Vastern Park, Reading

Rebuttal Proof

Design and Townscape

LPA Application Reference: 200328/OUT

Figure 29. RSAF Figure 6.10 Tall building location guidance 'overall height strategy' contours highlighted in yellow- the 'highest' at the centre and 'lower' at the periphery.

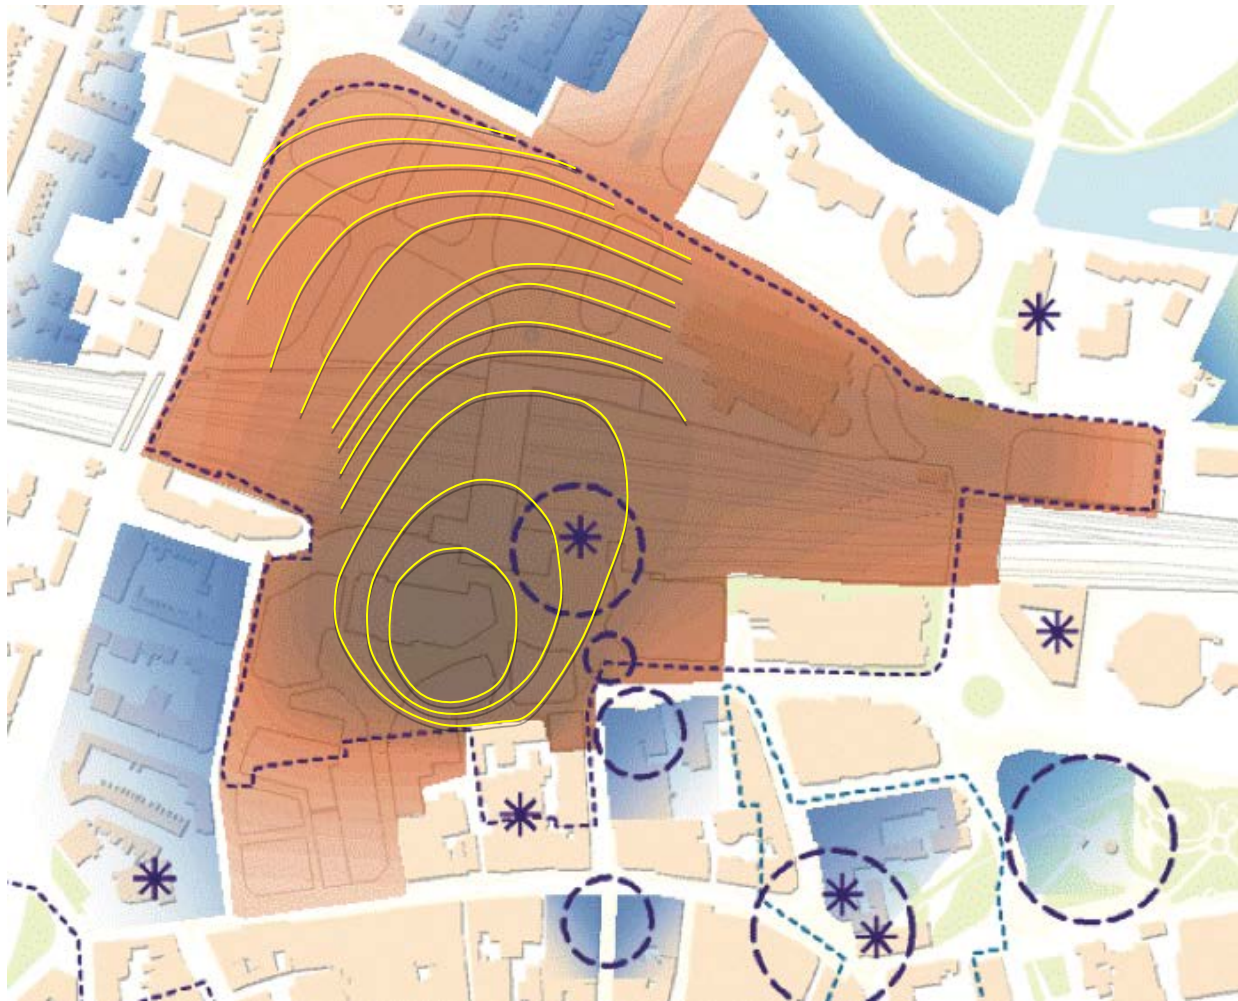
- 3.4.1 7.4.1 page 42 Mr Collado claims the text he sets out at parts a and b is stated in either the Local Plan or RSAF. That text does not appear in either document.
- 3.4.2 At 7.4.1(a). M Collado refers to a 'gradient of height' that 'reaches a maximum closest to the station'.
- 3.4.3 Whereas CR10(ii) 'CR10a, Station Area Cluster' states; 'follow a pattern of the tallest buildings at the centre of the cluster, close to the station' and 'step down in height from that point toward the lower building at the fringes'.
- 3.4.4 The RSAF confirms the location of the 'crown' (RSAF Fig. 6.5) is 'the area close to the southern station entrance' (RSAF 6.15 page 34). The cluster's centre lies over the station

(the 'nexus' at RSAF 6.12 page 34), and the tallest points in the cluster are the 'District landmarks' at RSAF Plots S2 and S11 (RSAF Fig. 6.8 and 6.9).

Figure 31. The Appellant's illustrative masterplan with Parameter Plan building footprints overlaid (arcades and oversailing areas have not been shown)

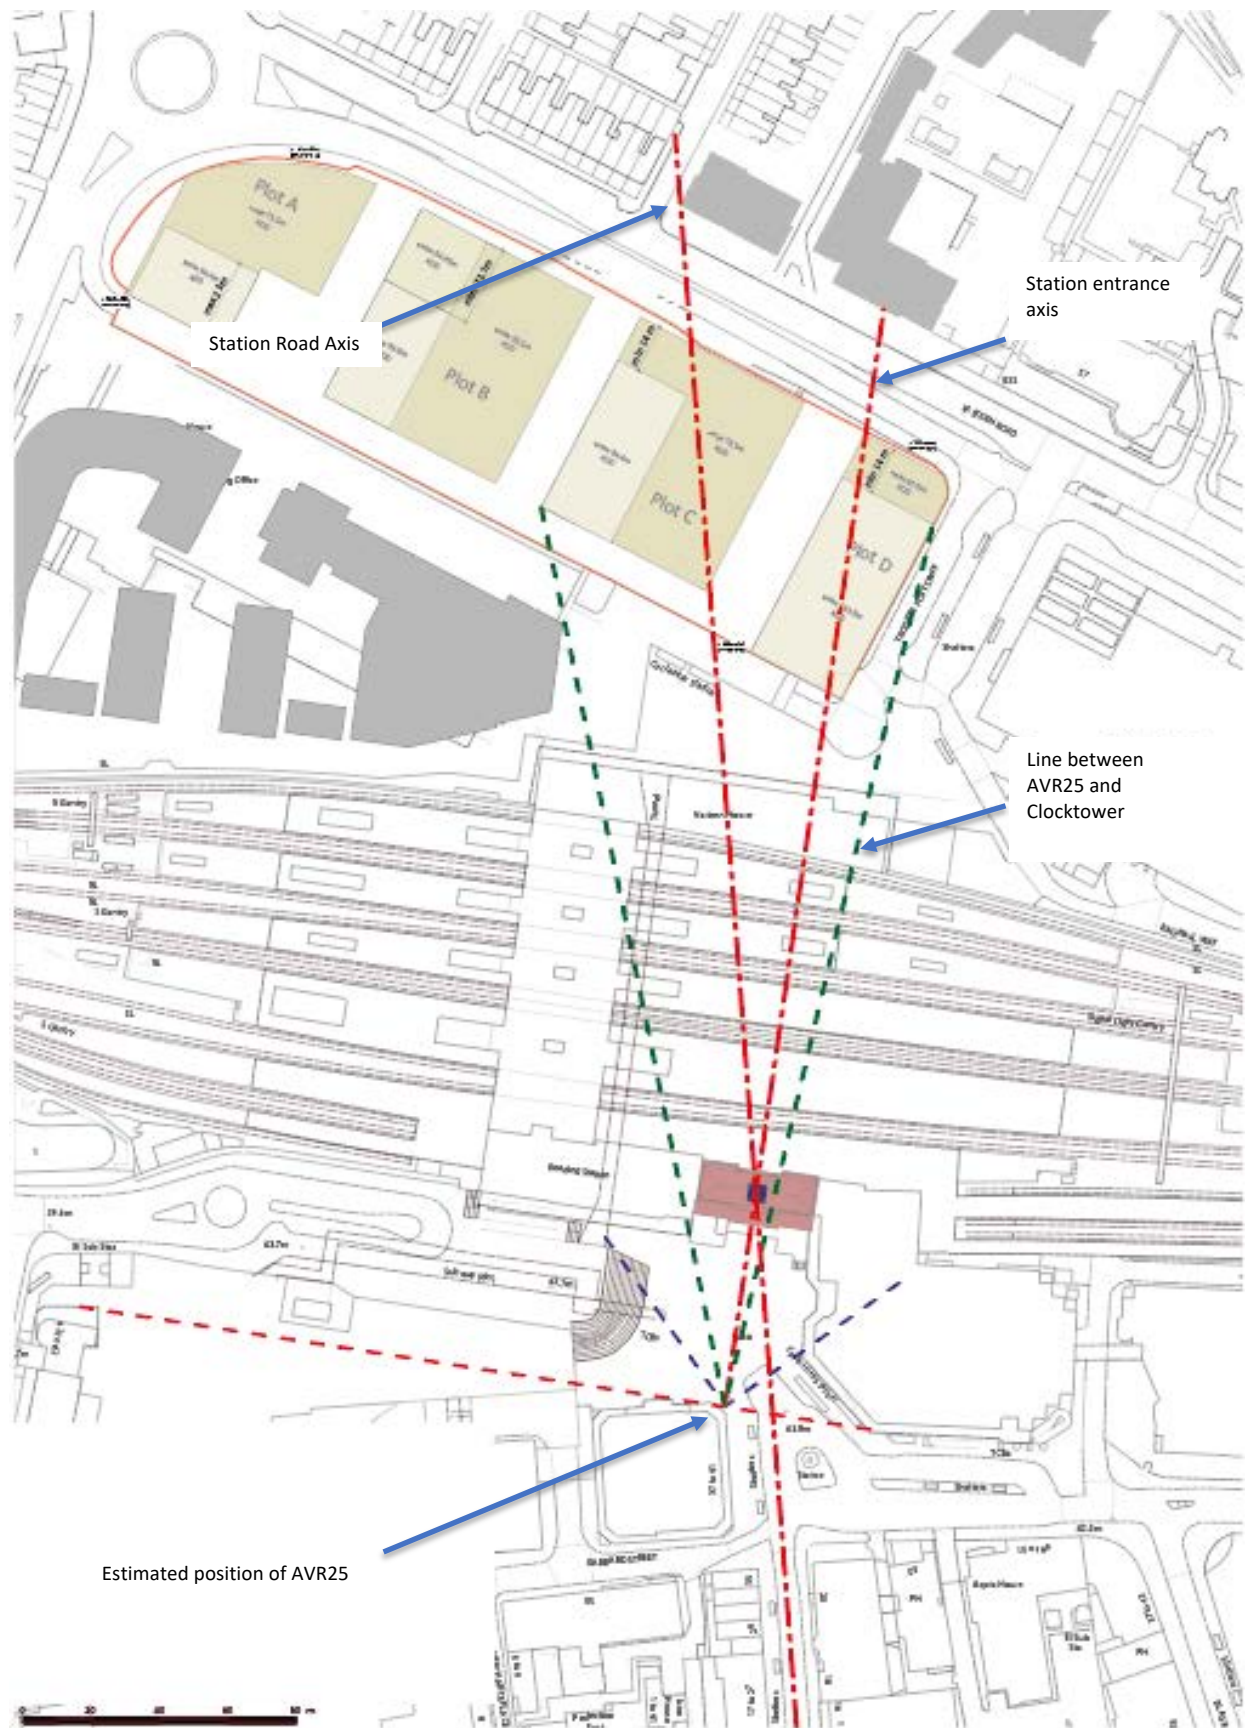
3.4.11 The illustration on page 56 is misleading as to the likely proportion of building footprints and the extent of the public realm.

- The extent of Block D is greater than shown when the oversailing and arcading are taken into account.
- The drawing shows podium level private open space with the centre of Blocks C and D, not the public realm.
- The illustrative scheme buildings are set back from surrounding roads when the parameter plan permits them to creep much closer, narrowing pavements and areas for planting.
